**RE: Construction Permit Application for a Proposed Utility Waste Landfill, Ameren Missouri
Labadie Energy Center, Franklin County, Missouri, Response to Comment Letter dated May 7,
2013**

Construction Permit Application
Proposed Utility Waste Landfill
Ameren Missouri Labadie Energy Center
Franklin County Missouri

Response to MDNR-SWMP Review Comments

PREPARED FOR Ameren MISSOURI	SHEET 8 PROPOSED UTILITY WASTE LANDFILL CELL 3 GRADING PLAN (TOP OF LINER)	LOCATION 001009 LABADIE ENERGY CENTER	CLASS 02010
ST. LOUIS, MISSOURI	JANUARY 2013	REV. 0

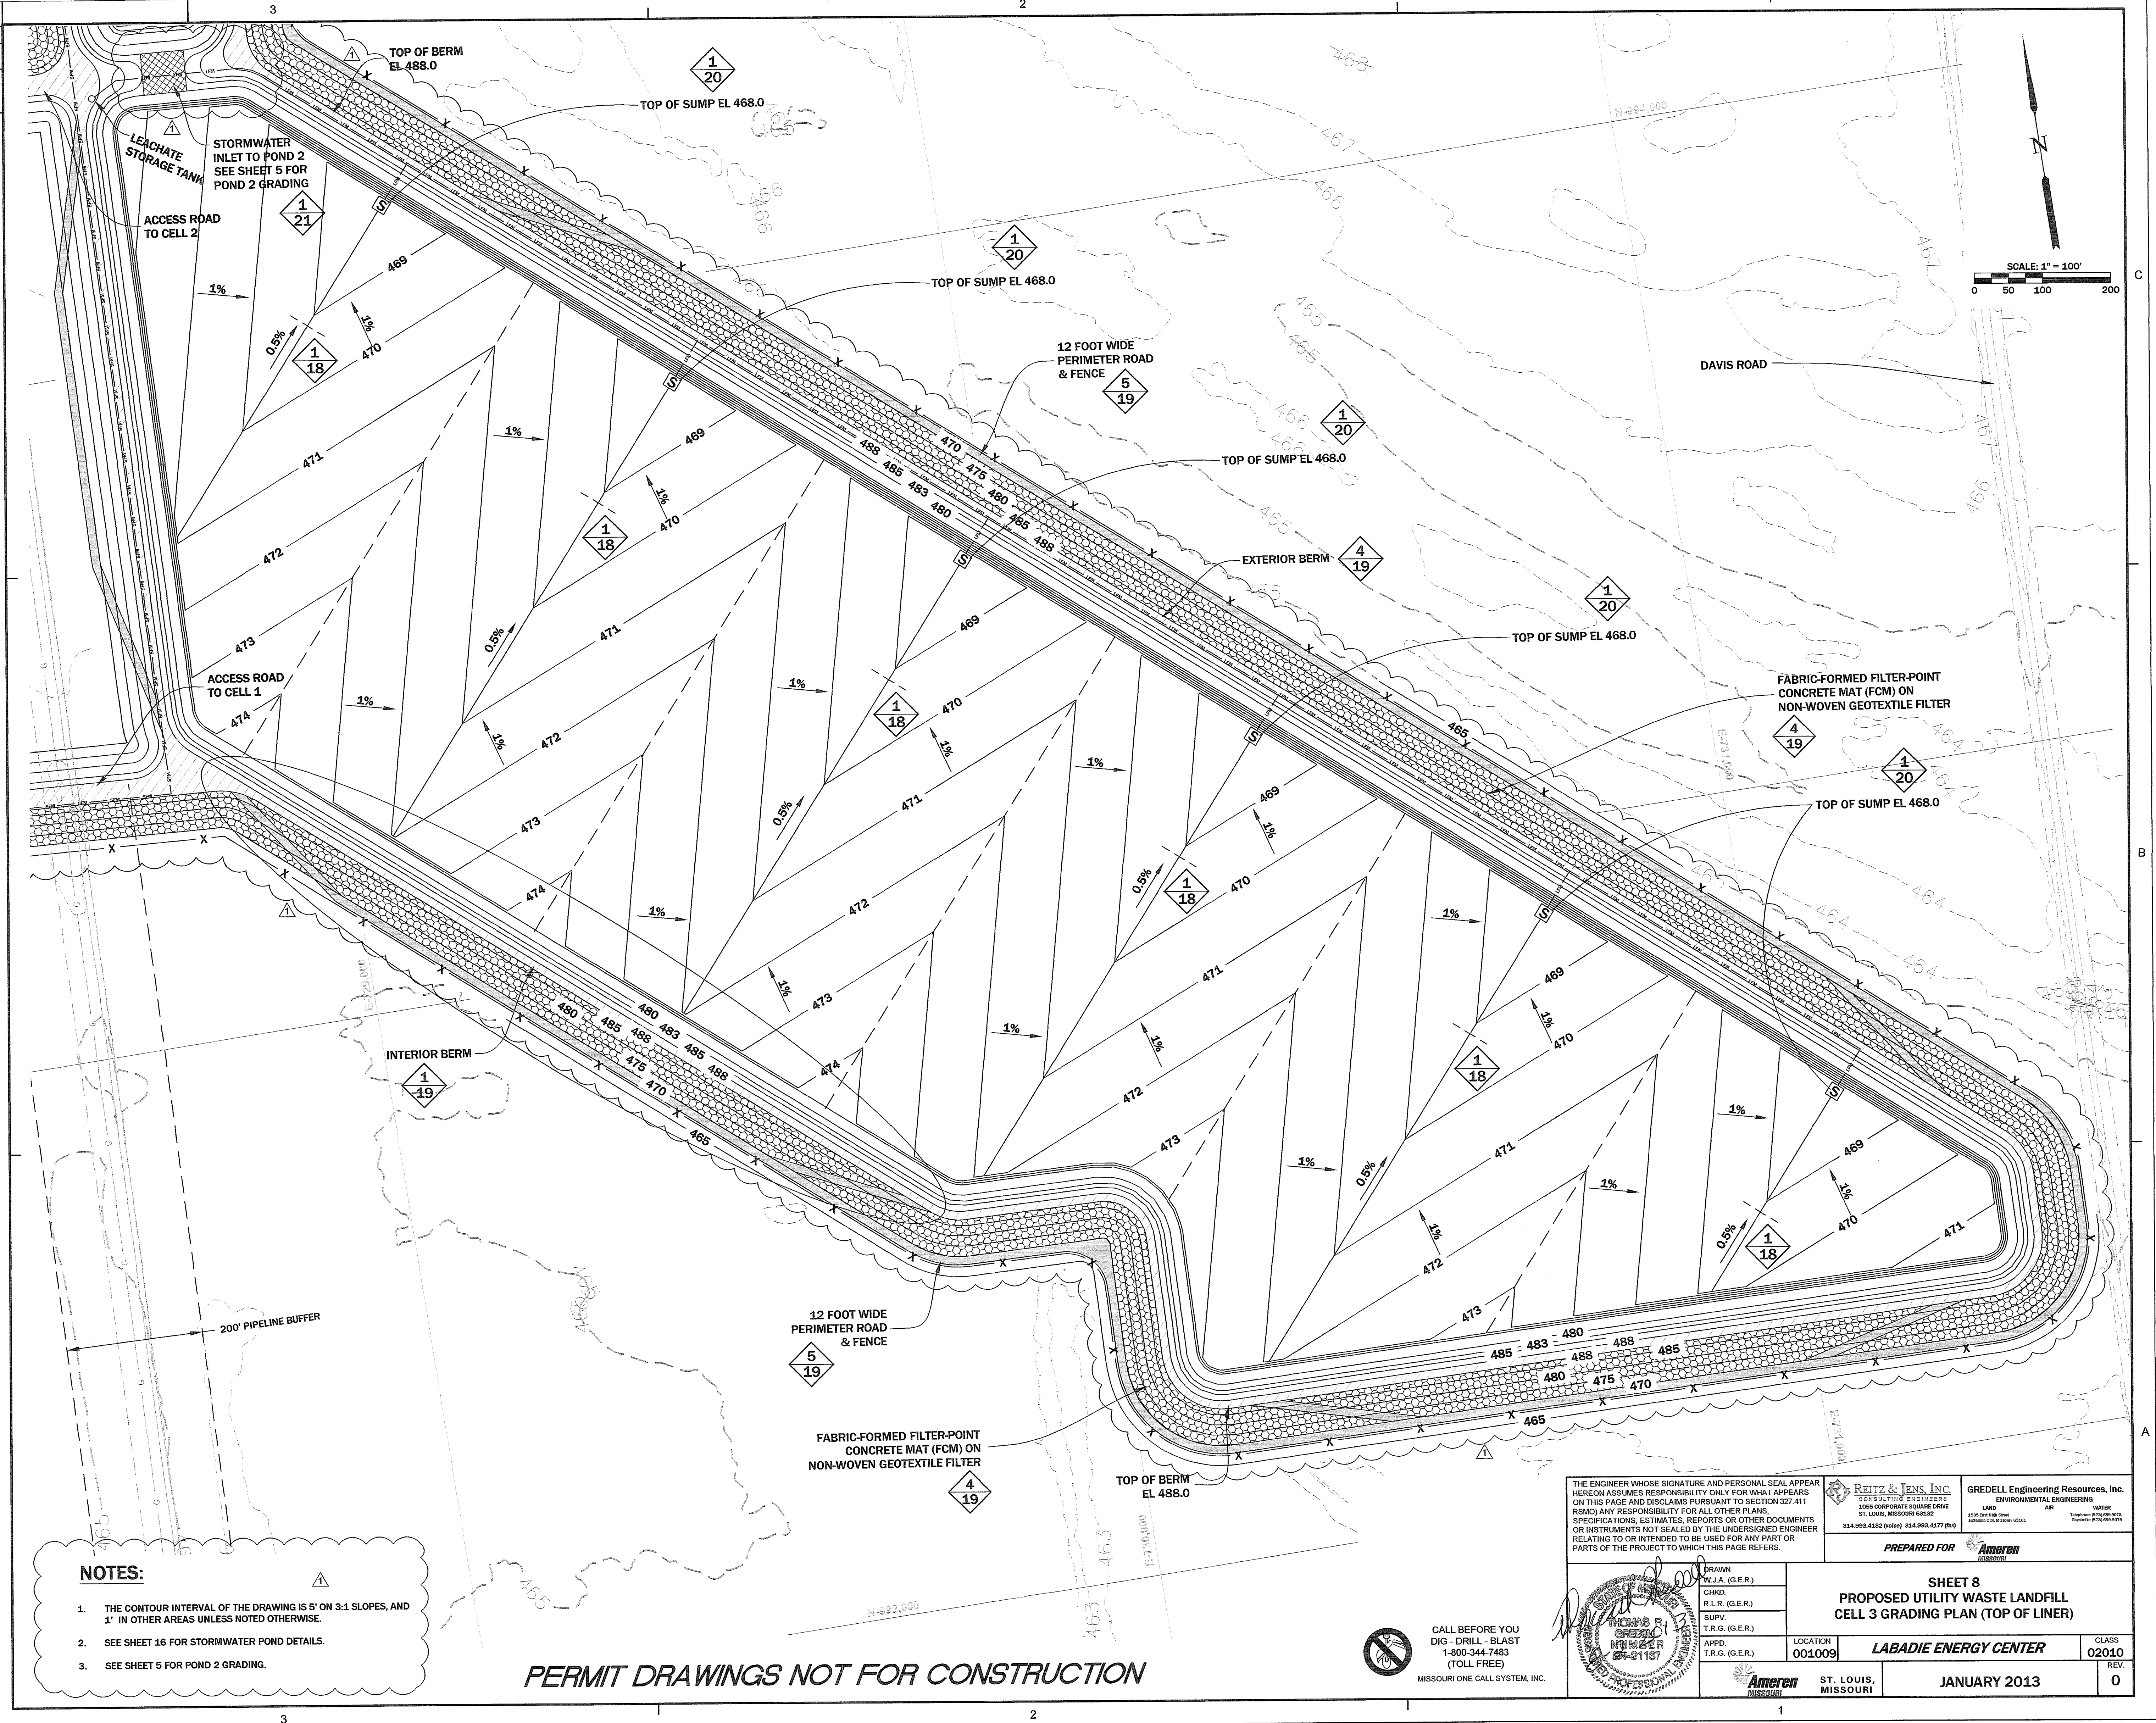
MDNR 8 Remove Note 2 from Sheets 6-9 and 11-14. **Response:** Note 2 has been removed from revised plan Sheets 6 through 9 and 11 through 14, and the notes on each Sheet have been renumbered as appropriate.

MDNR 9 Please depict the limits of Fabri-Form installation along all berms on all sheets that illustrate the location of the material. **Response:** Sheets 6 through 9 and 11 through 14 have been revised to show the installation of FCM on all exterior berms. Because of the large scale of Sheets 5 and 10 a note was added to each sheet to address this comment.

MDNR 11 Show arrows from call-out details to their corresponding features on Sheet 8. **Response:** Sheet 8 has been revised to show arrows from call-out details to their corresponding features on the sheet.

PRINT DIST.		
REVISIONS		
REV.	W.O.	SYM
1		△
08/02/13: ADD FABRIC- FORMED TO OUTSIDE TOP OF BERM; ADD HATCH TO STORMWATER INLET; REMOVE NOTE (2.).

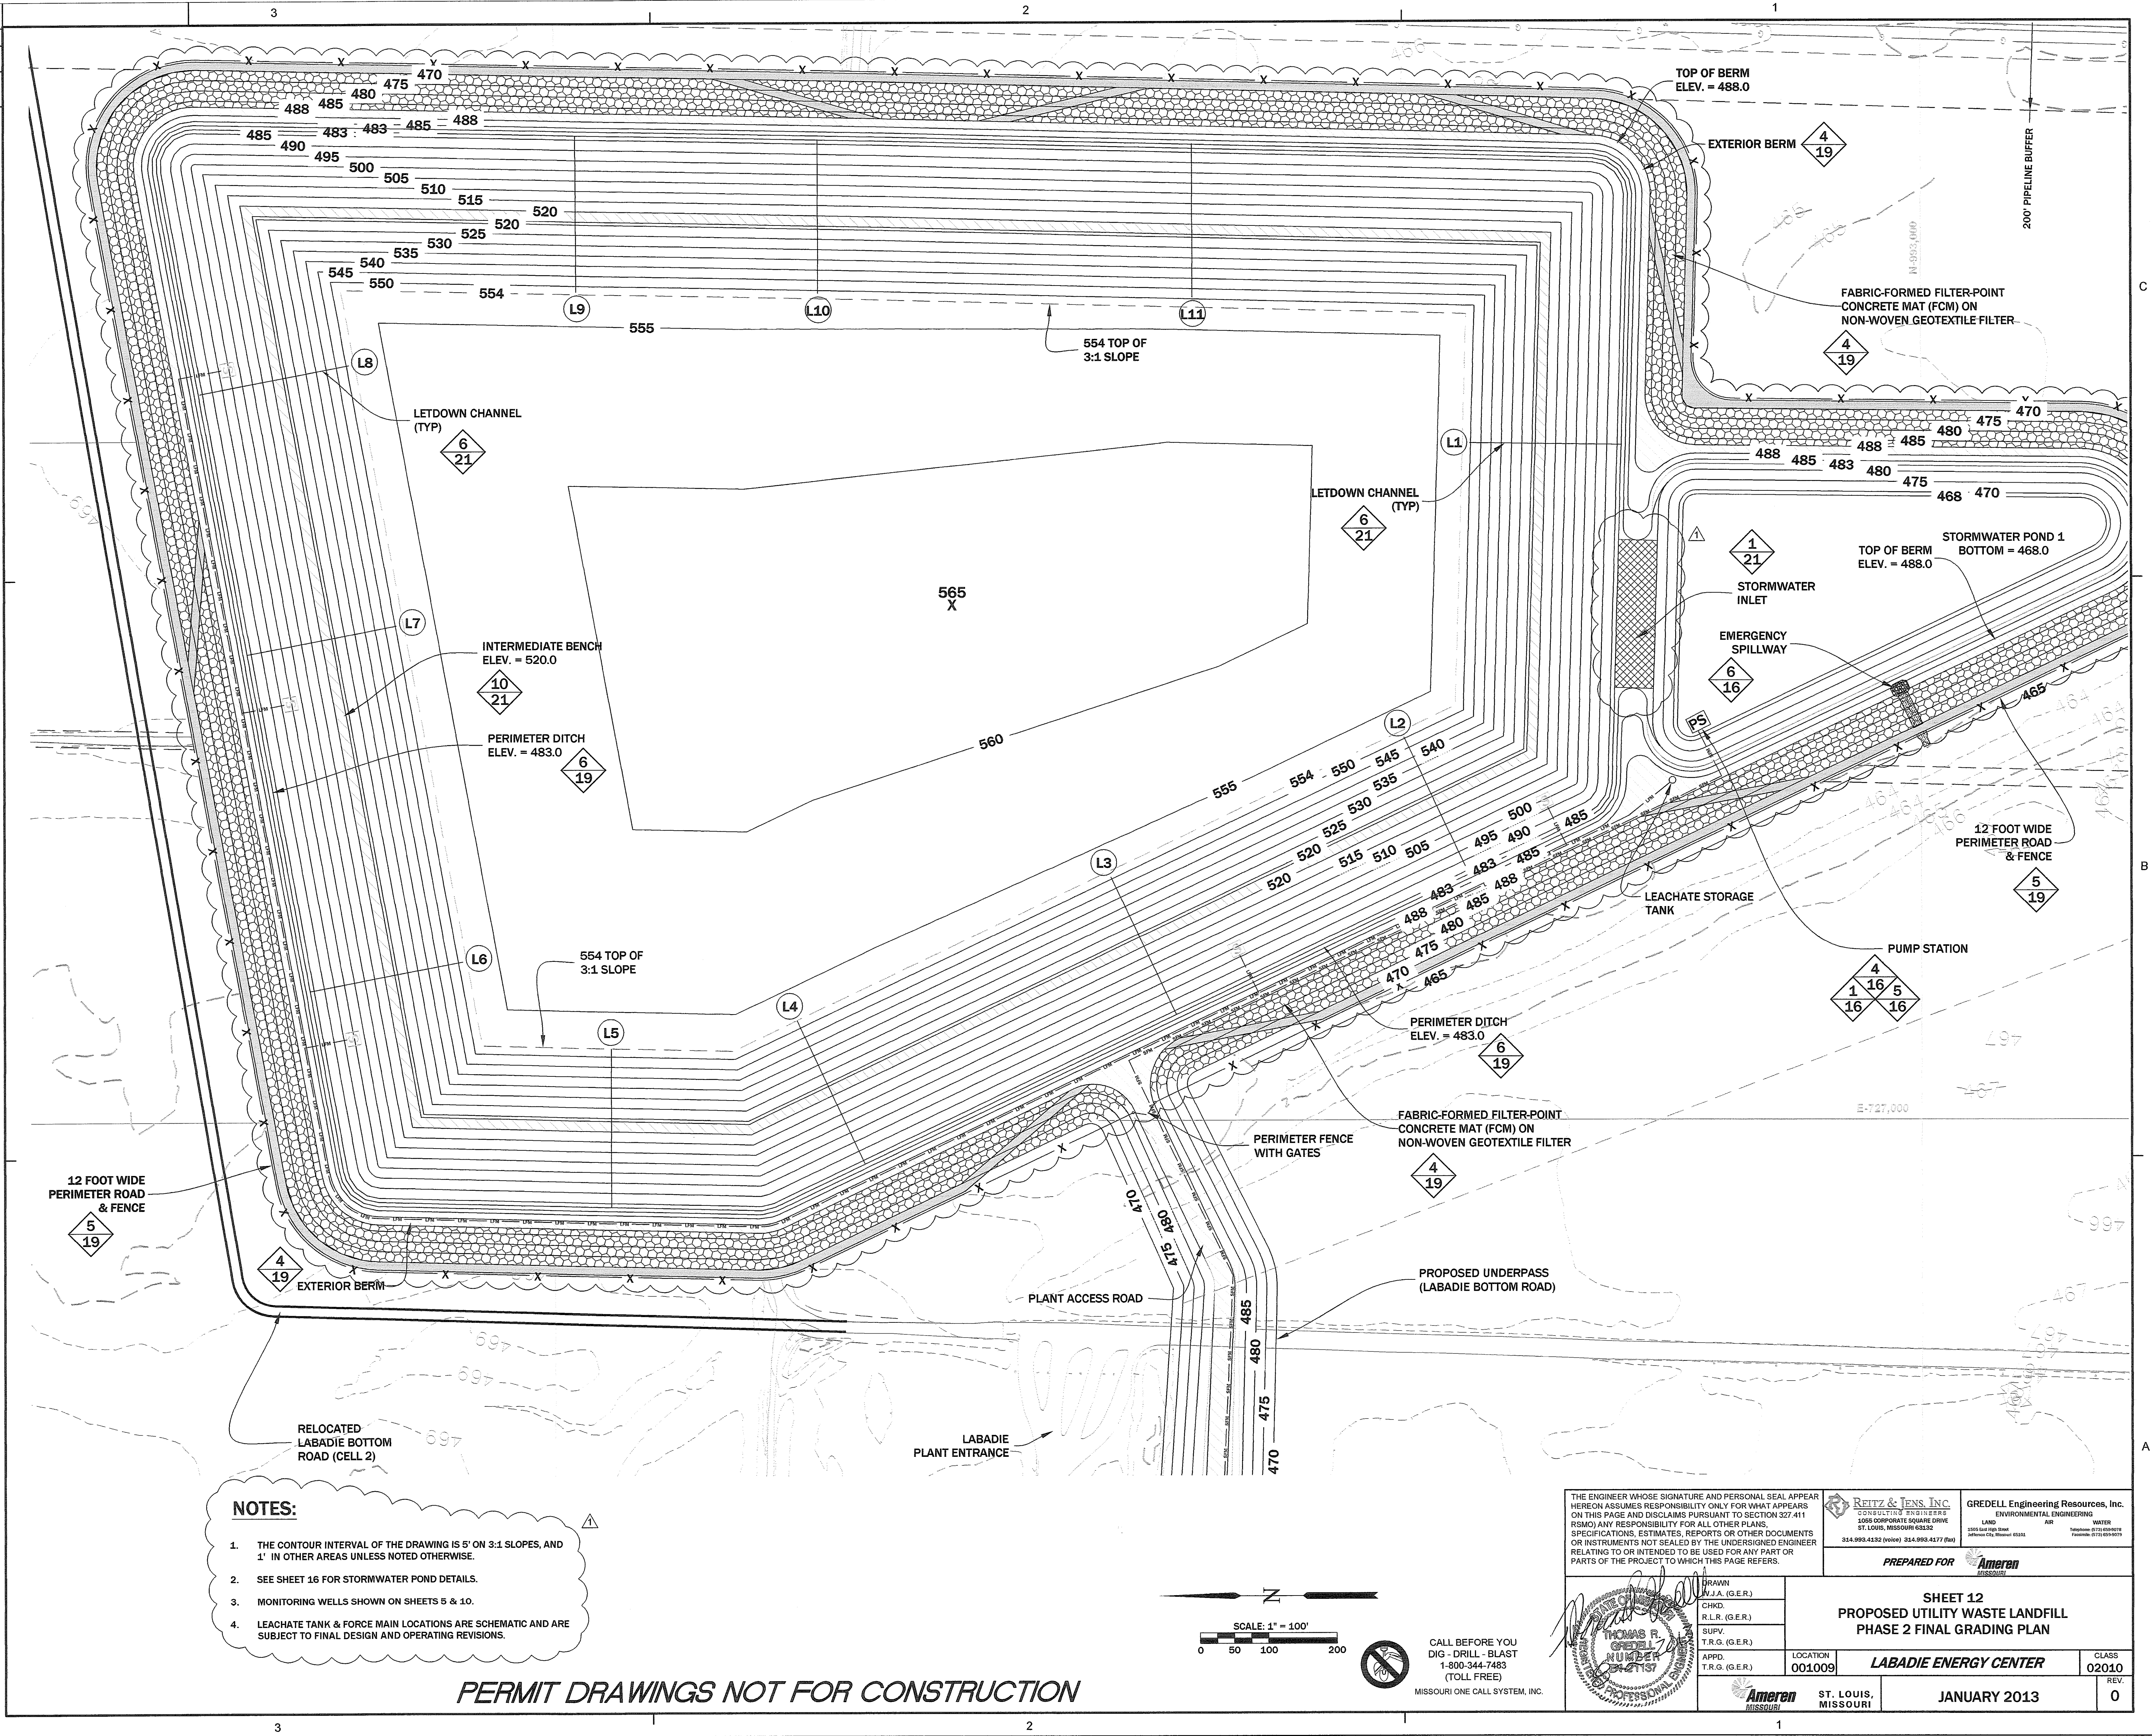
MDNR 28 The exterior slopes of the intermediate berms are not covered with Fabri-Form concrete mat. **Response:** Sheets 6 through 9 and 11 through 14, and Section 3.3.2.1 and 3.3.2.3 have been revised to show the installation of FCM on all exterior berms.

PRINT DIST.	REVISIONS
REV. 1	W.O. SYM
08/02/13: REMOVED NOTE (2). ADD FABRIC FORM ON OUTSIDE FACE OF BERM; ADD HATCHING IN STORMWATER INLET.
